**RE: FTAA-2603-1185 HUNUA QUARRY DEVELOPMENT SUBSTANTIVE APPLICATION
LODGED UNDER FAST-TRACK APPROVALS ACT 2024 – UPDATES TO APPLICATION
FOLLOWING FURTHER CONSULTATION FEEDBACK**

PRELIMINARY COUNCIL RFI'S

TO	Cam Russell	FROM	Parviz Namjou
	Winstone Aggregates	DATE	18 May 2026
RE	Response to Groundwater Queries - Fast Track Application - BUN60464053

Figure 1: Reproduction of Bioresearches (2007) vegetation map, consented pit boundary and proposed mitigation planting areas.

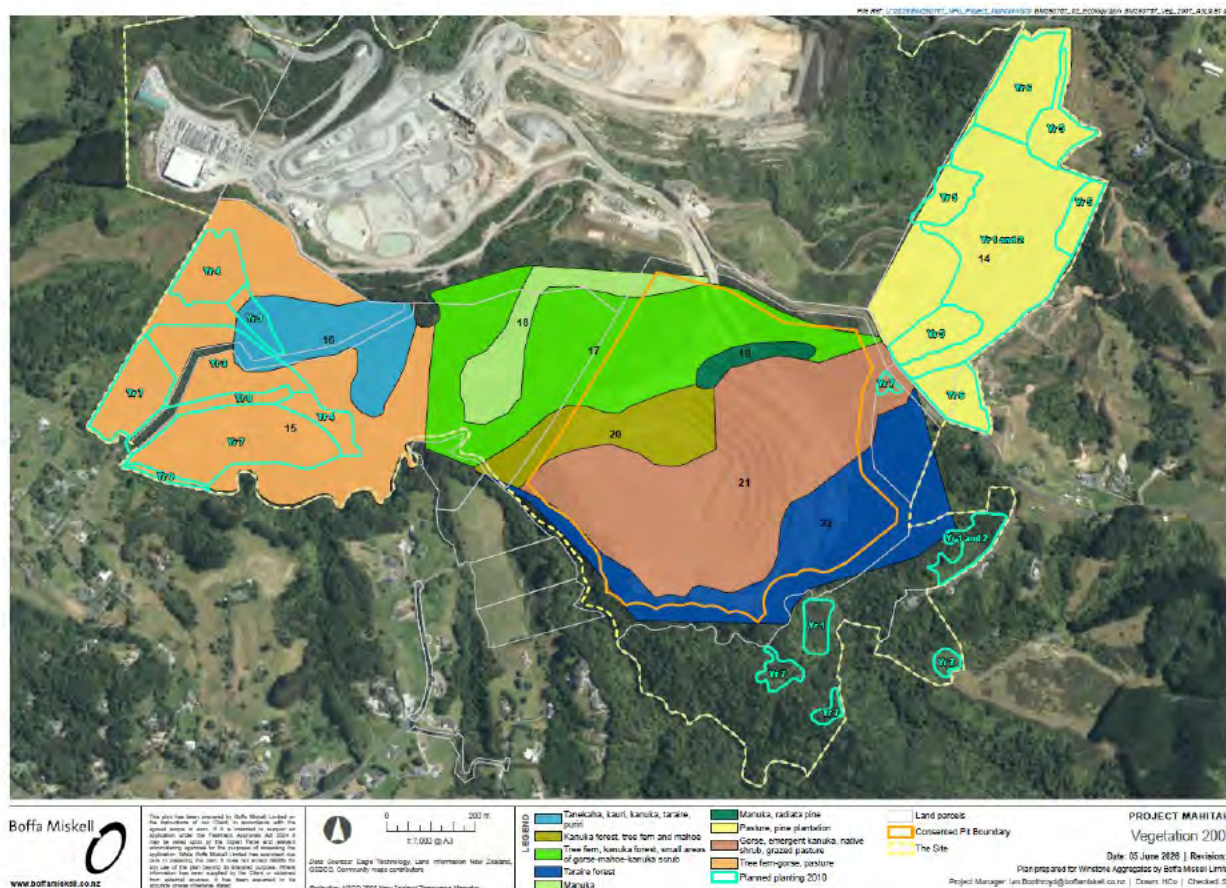
ECOLOGY Andrew Rossaak	Values Assessment Terrestrial ecology 1. Provide the locations of the existing offsets from past quarry consents, the indicated outcome of these offsets to be achieved under the past consents and what ecological values have been assigned to these sites in this assessment. Clear maps would assist. 2. The existing 39.9 ha of revegetation established under the 2009 consent has not been covenanted as required. The application proposes to “relocate” the required covenant areas to other parts of the landholding within the quarry zone. The ecological equivalence information of this relocation is missing, including evidence that the relocated areas provide equivalent or superior biodiversity values to those originally intended (to ensure the effects management of the original consent is upheld). Has additional offset to address loss of time reaching the intended outcome been included (i.e. starting from 0 again) ? 3. RECCE plot survey data has not been provided for the receiving offset sites (Focus Areas 2 and 3 – Meremere Quarry and Hunua Ranges). Without equivalent baseline data for receiving sites, it is not possible to independently verify the Biodiversity Offset Accounting Model (BOAM) calculations or confirm that only attributes present at both impact and offset sites have been entered into the model, as required by BOAM methodology.	29/05/26 via email Partial response excluding responses to Questions 1; 2e; and 9a. 18/06/26 via email Finalised memo including responses to outstanding questions.	<u>Feedback received 19 / 06 / 2026</u> No further questions posed. A number of points of disagreement with applicant's response identified, particularly relating to methodology applied to offset calculations and value setting.

Bioresearches Ltd prepared an ecological assessment report (dated 2007) to support the consent application. Vegetation types and extents identified in the Bioresearches report (based on surveys undertaken in 1999-2001) are listed in Table 1 and mapped in Figure 1. (Figure 2 shows aerial imagery from the survey period for comparison.

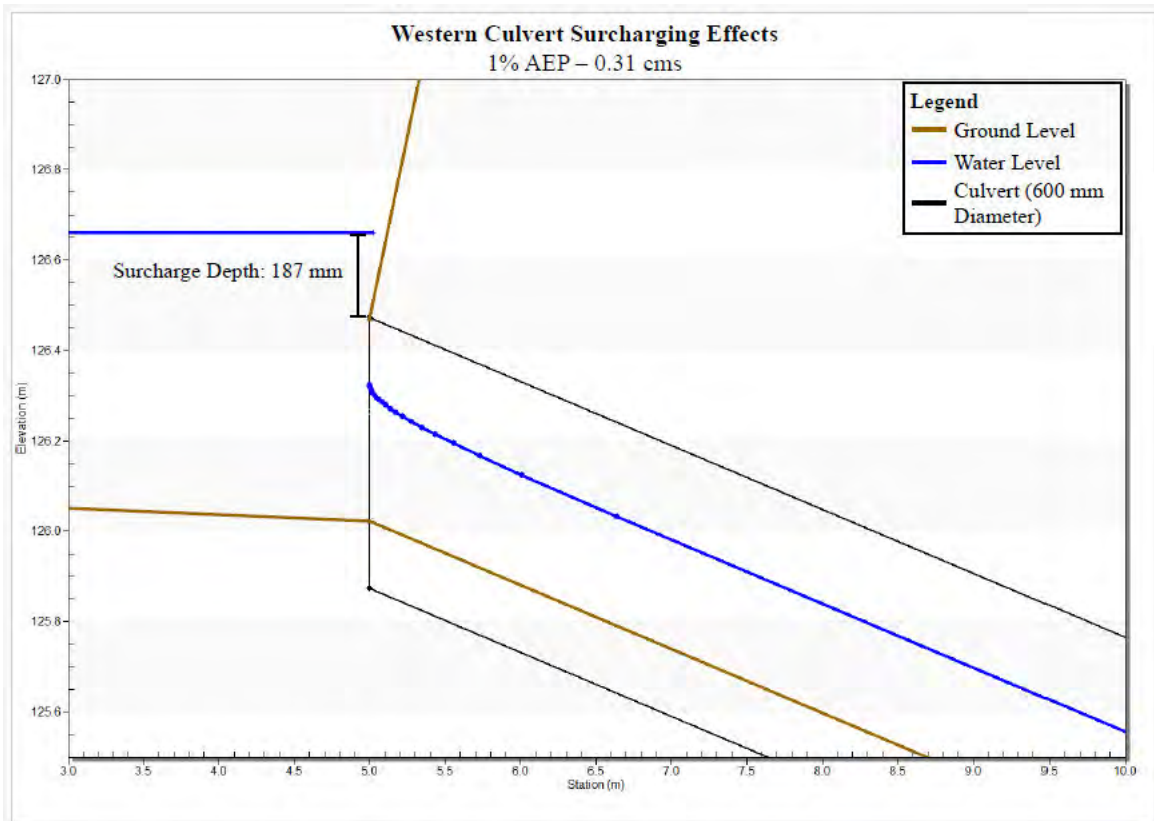
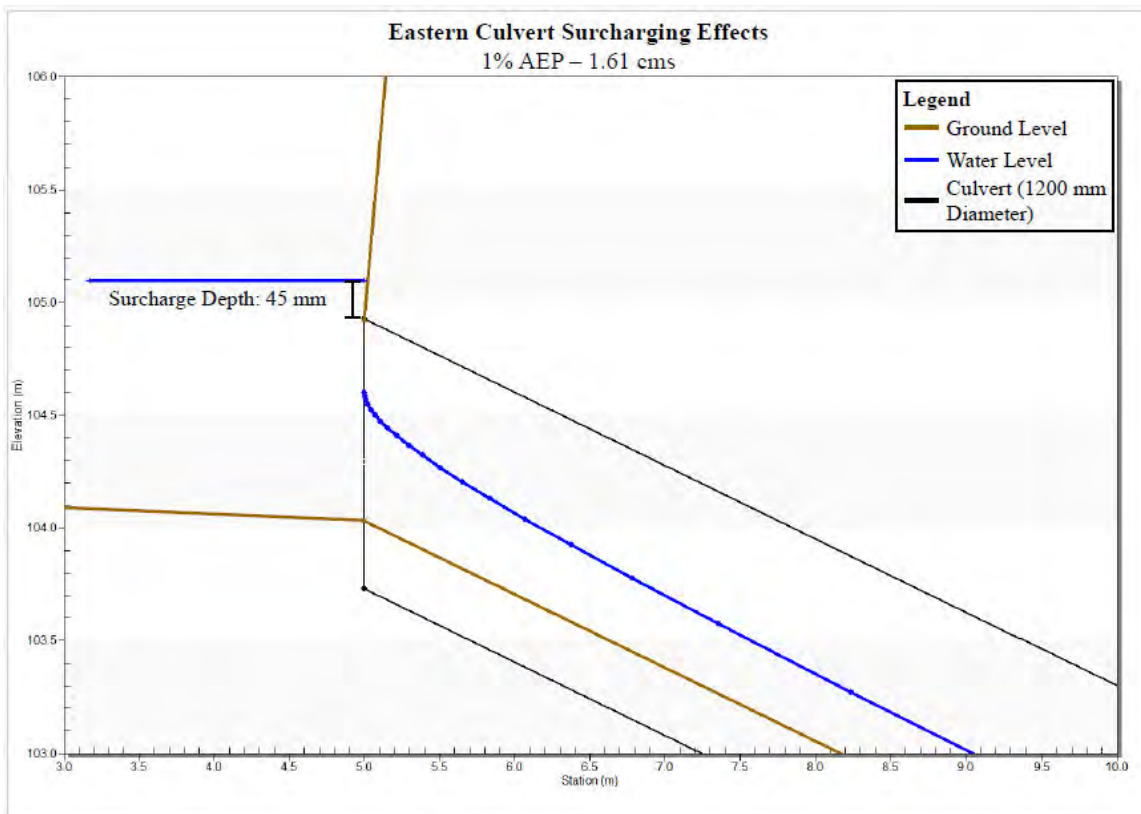
- Clarification on impervious area
- Questions relating to flooding and the AEP flood plain with regards to culverts and the stream realignment
- Feedback on consent conditions

Below are indicative plans derived from culvert sizing software that show the 1% AEP flood level at each culvert, the depth of surcharge at the upstream end of the culverts, the 25% embedment and water level through the pipe.

Based on LiDAR of the site, the top of the channel bank is approximately 0.46 m higher than the 1% AEP flood level, indicating that there is some capacity if the culvert were blocked and flow backed up. The calculated maximum surcharge depth is 0.187 m which is less than the 0.3 m stated in the technical report.

The gradient of the culvert is representative of the natural channel but note that the x and y axes are not 1:1, which is exaggerating the steepness in the image above.

Based on LiDAR of the site, the top of the gully bank for the Eastern Culvert is approximately 10 m higher than the 1% AEP flood level, indicating there is excess capacity should the flow back up due to a blockage.

As above, note that the maximum surcharge depth is less than stated in the technical report; and that the gradient is exaggerated in the image.
